STATEMENT OF RESPONSE TO AN BORD PLEANÁLA'S CONSULTATION OPINION

Cairn Homes Properties Limited.

**IN RESPECT OF A
PROPOSED RESIDENTIAL DEVELOPMENT AT
NEWCASTLE SOUTH, NEWCASTLE, CO. DUBLIN
JUNE 2022**

Figure 3.2 – Sequential Development

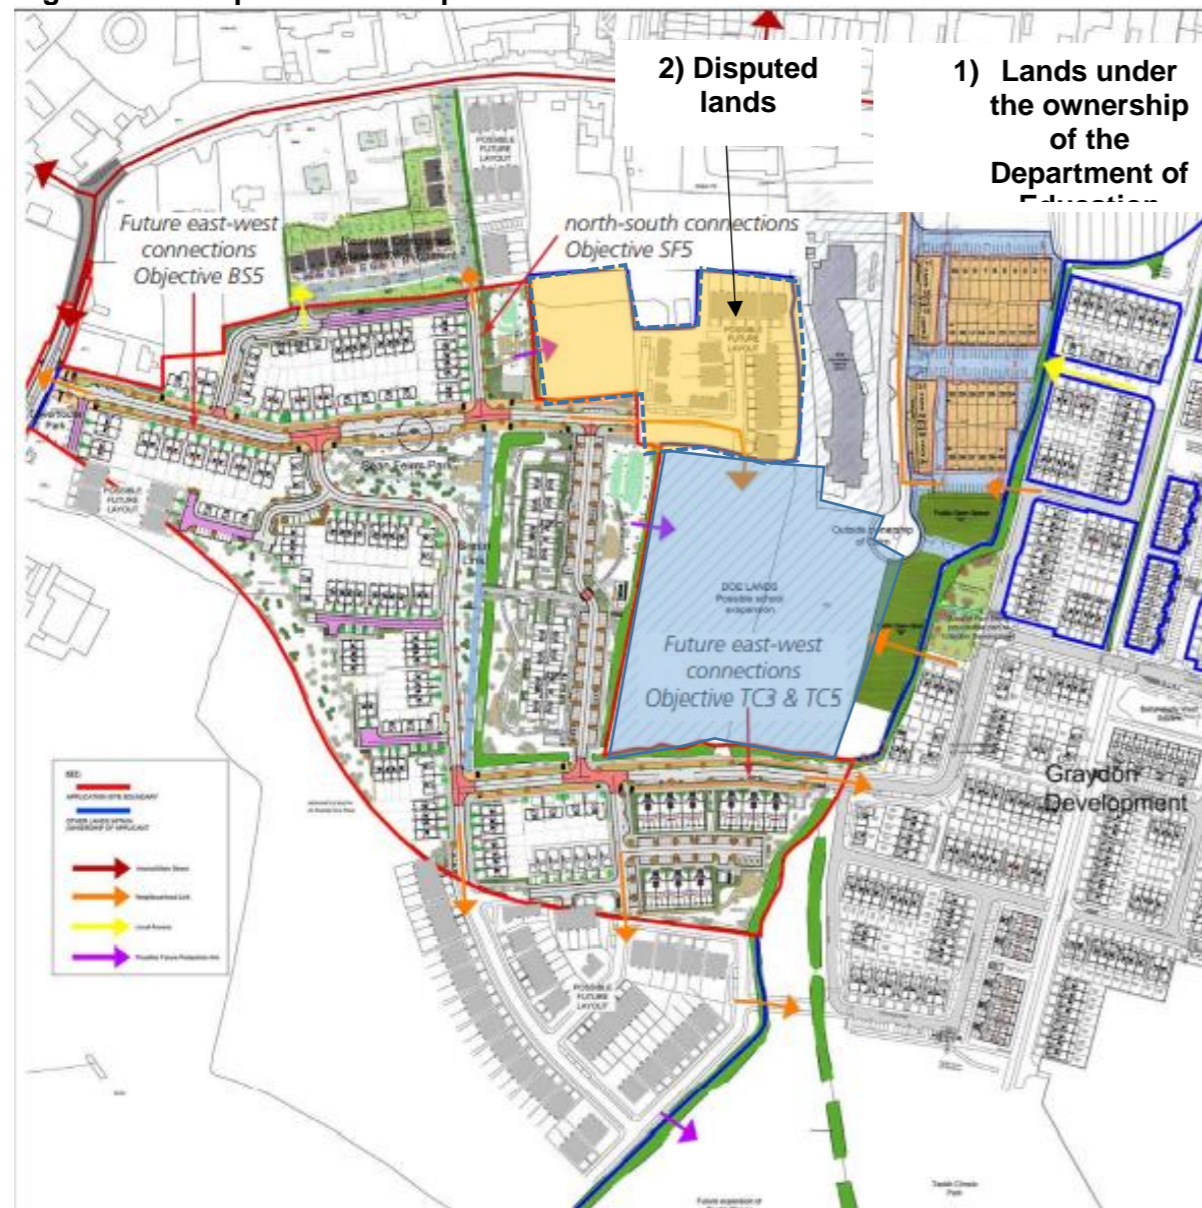
“2. The application should indicate how the development will facilitate the sequential development of the settlement and should ensure that the proposal would not compromise the development of Village Core lands in line with the provisions of the Local Area Plan or where there is potential for impact, justification of same should be included with the application documentation.

3.92 In response to this item, the proposed development will be sequentially developed from the north (St. Finian’s Way), which is adjacent to the main street and village core, and to the east from Graydon (currently under construction by Cairn), which will deliver full east west connectivity across the southern side of Newcastle. It is highlighted that the 2 main largest parcels of undeveloped land relate to 1) Department of Education owned lands and some 2) disputed owned lands which Cairn currently are not able to develop and as such the lands are not available.

Figure 3.5 – Proposed Roads Infrastructure

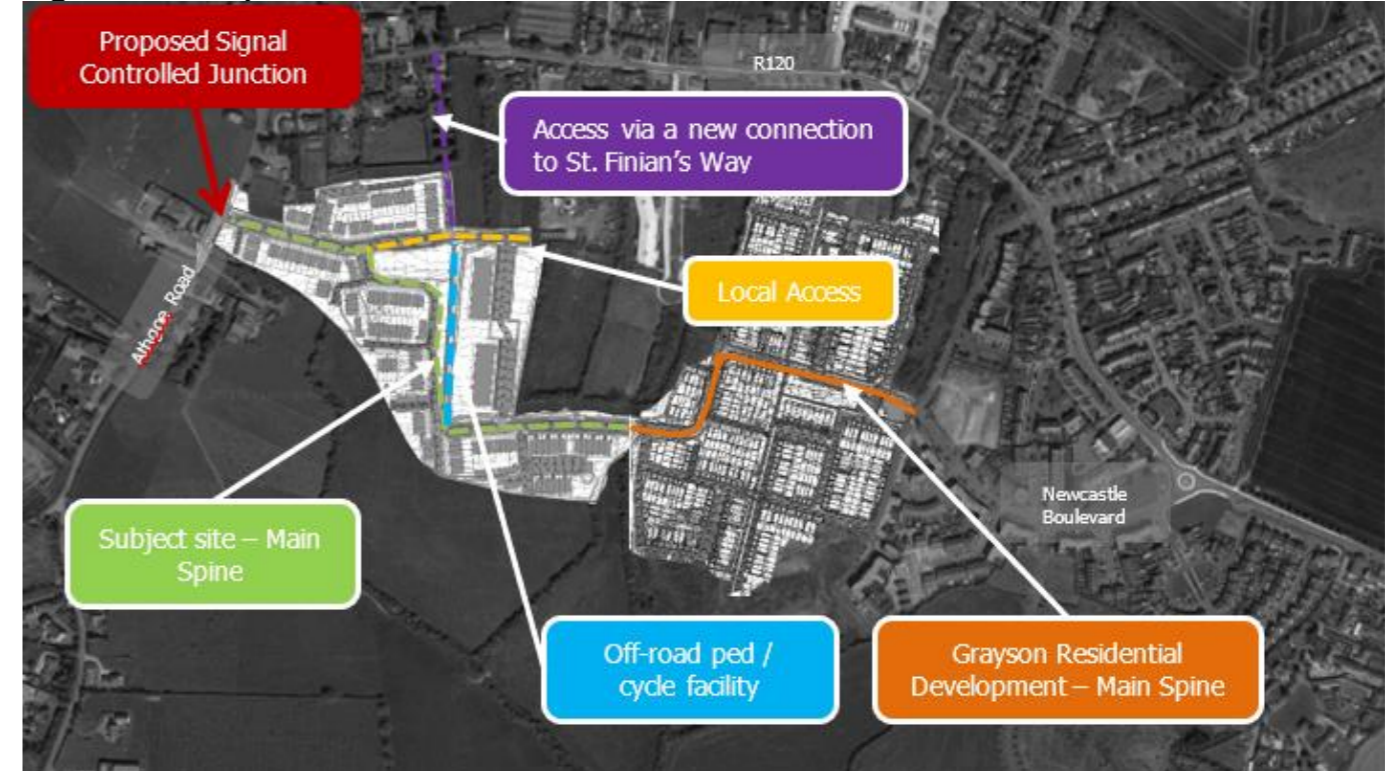
“3. Site layout plans illustrating how the proposed development is aligned with the roads, movement / connections, open space and other framework elements that apply to these lands under the County Development Plan and the Newcastle Local Area Plan, and/or DMURS. This should include pedestrian and cycle connections between neighbourhoods, parks and the Main Street in line with the objectives of the LAP. Where there is potential for deviation or divergence from the Plans, justification of same should be included with the application documentation. The documentation should, in so far as is practical, also illustrate how the development will integrate with and facilitate the development of adjoining undeveloped zoned lands in accordance with the principles and guidance of the LAP.

3.100 In response to this item we refer the Board to drawing no. 210026-DBFL-TR-SP-DR-C-1001, prepared by DBFL Consulting Engineers, which shows the existing, proposed and allowance for future pedestrian and cycle linkages.

Figure 3.23 – Connection to the Main Street

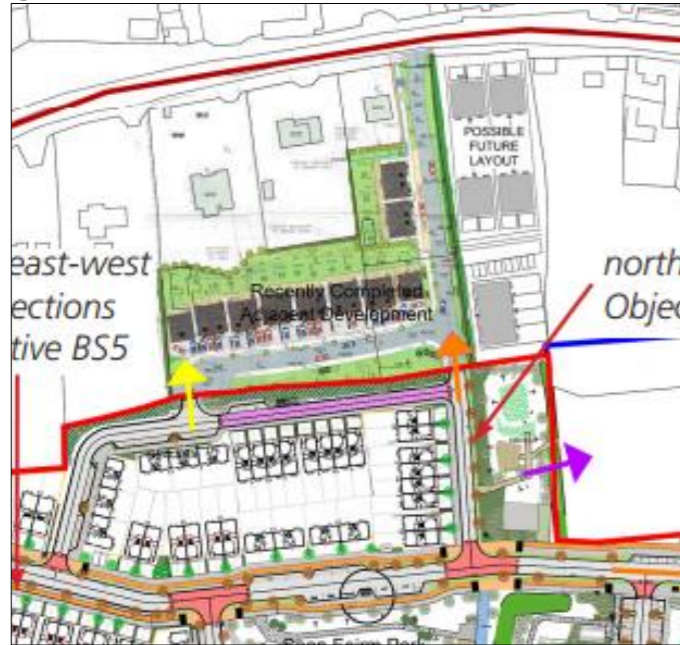
- The Planning Authority noted the following concerns in relation to LAP infrastructure:
- Delivery of adequate link streets to the Main Street. The connection of the development to the street adjacent to St Finians National School and also a full connection to St Finan's Way are required.*

- 3.150 In relation to links to the Main Street the proposed development provides a link to the boundary with the adjoining St. Finian's Way to the north (which is to be taken in charge, providing an appropriate link to the Main Street).

Figure 3.26 – Land Ownership – Burgage Park South

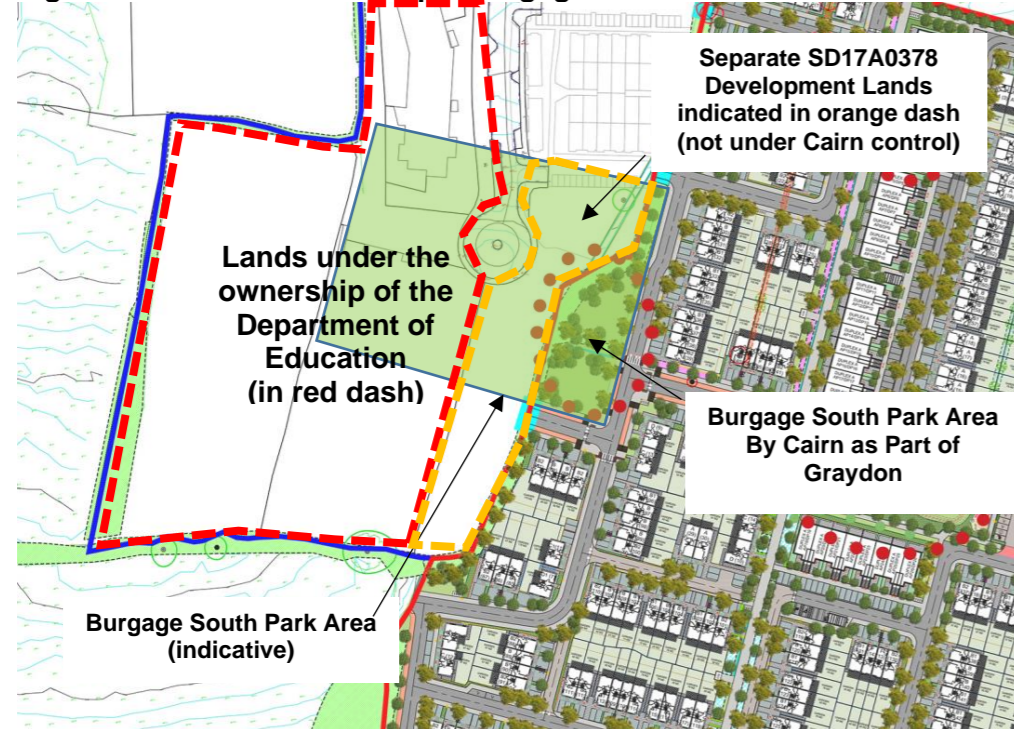
- Delivery of the Burgage South Park

3.153 It is noted the majority of the Burgage South Park Lands are under the ownership of the Department of Education. Cairn delivered a portion the Burgage South Park Lands on the eastern side of the park as part of the Graydon Development. However as can be seen from the graphic below, St. Finian's School (Building and road including roundabout), encroaches significantly into Burgage South Park.

Figure 3.27 – Phasing Plan

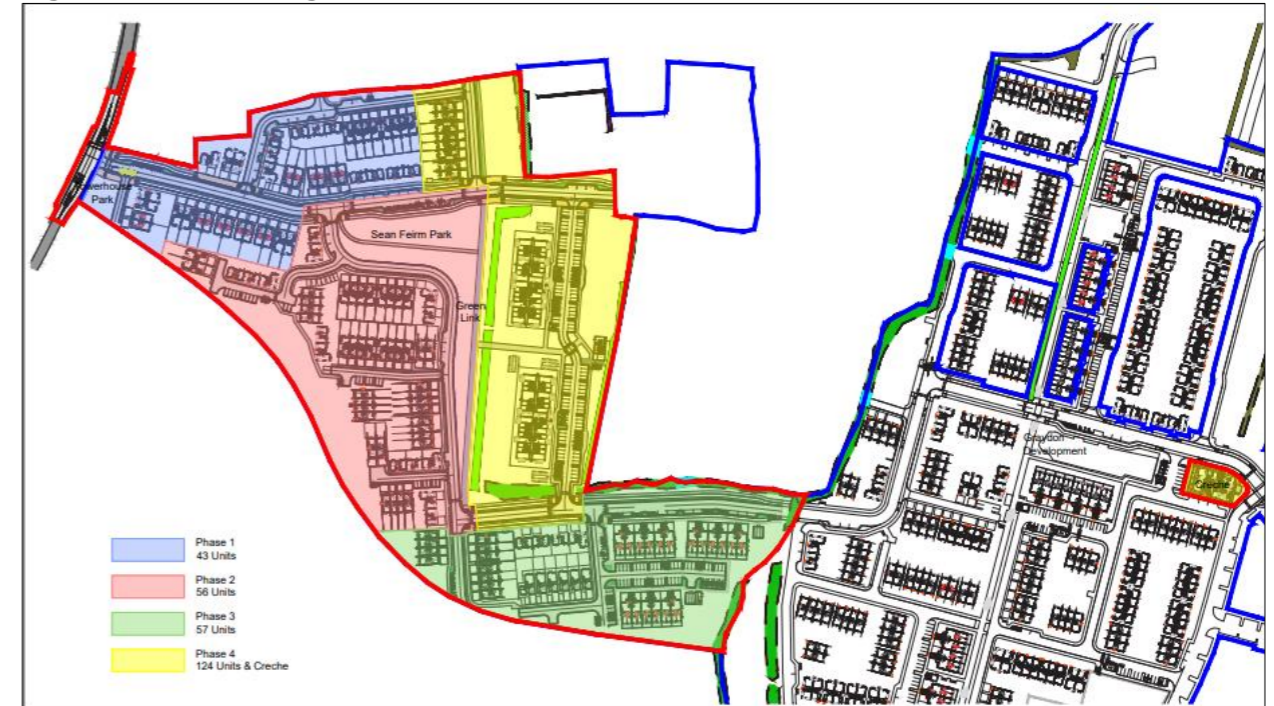
3.168 Item 6 of the An Bord Pleanála opinion seeks:

6. A detailed phasing plan for the proposed development. Such plan should demonstrate how the phasing provisions of the Local Area Plan are addressed within the proposed development or as part of adjoining permitted developments.

3.169 The subject development site is located within the Newcastle LAP lands. The Newcastle LAP 2012 (Extended to December 2022) includes a movement framework map which indicatively shows the proposed road network and green links within the LAP lands.

Figure 3.36 – Proposed Junction – Athgoe Road

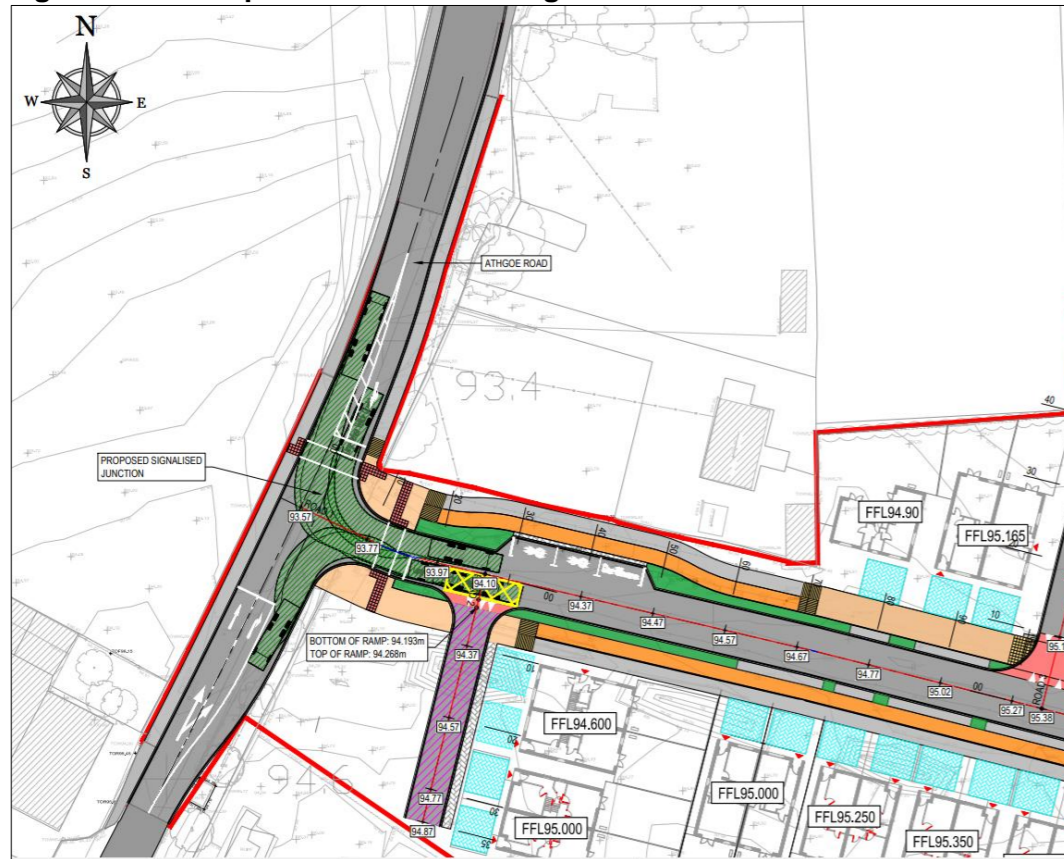
3.8.3 (c) Athgoe road

- 3.183 In response to this item, in consultation with South Dublin County Council, the proposed development will be accessed from the L6001 Athgoe Road to the west of the site. The access point from the L6001 Athgoe Road to the west of the site is proposed to be updated to a signalised junction. The proposed signalised junction aims to improve pedestrian accessibility to the existing footpath on Athgoe Road and improve connectivity to Newcastle Main street. This is shown on drawing no. 210026-DBFL-RD-SP-DR-C-1101 Proposed Roads Layout, prepared by DBFL, (see extract below).

Figure 3.38 – Taken in Charge Drawing

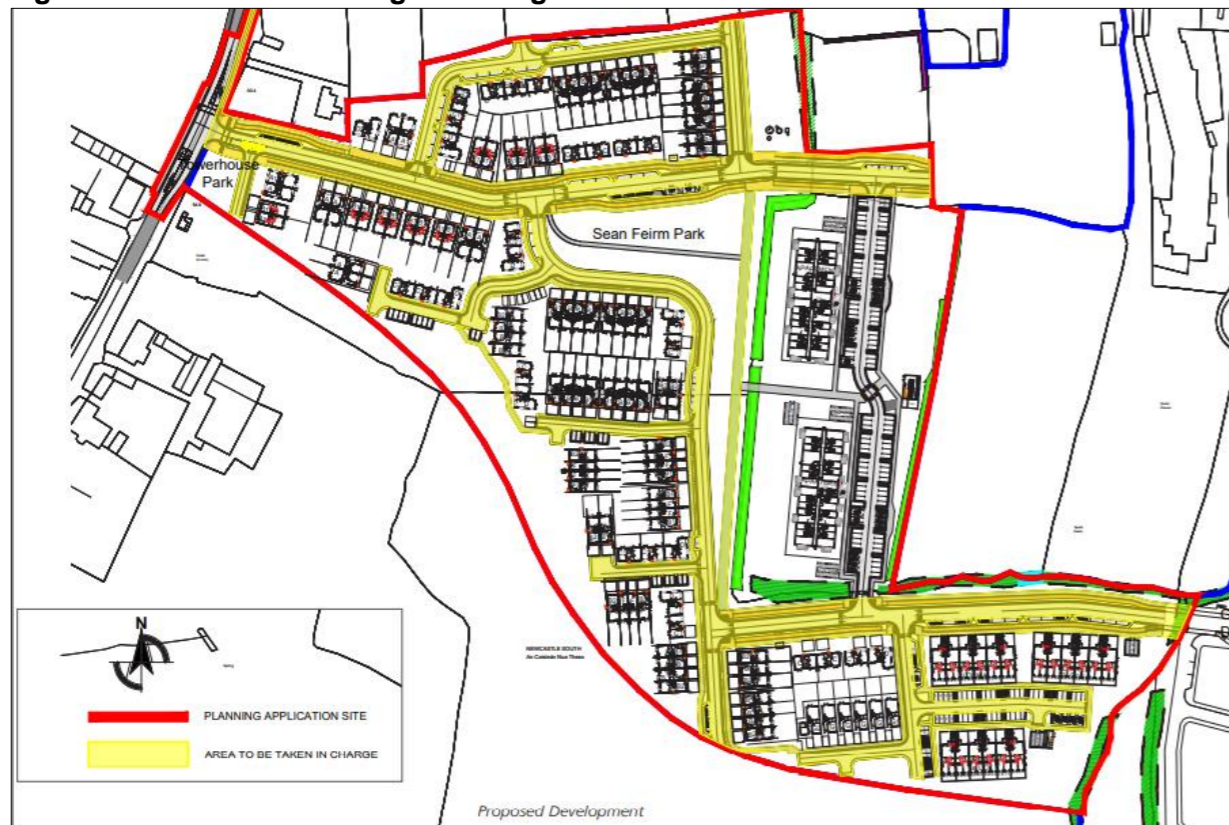
“A plan clearly identifying the areas intended to be taken in charge by the local authority.”

3.195 In response to this item we refer the Board to drawing no. *MOLA - XX - 00 - DR - A - XX - 0121 - S0*, prepared by MOLA (extract below).
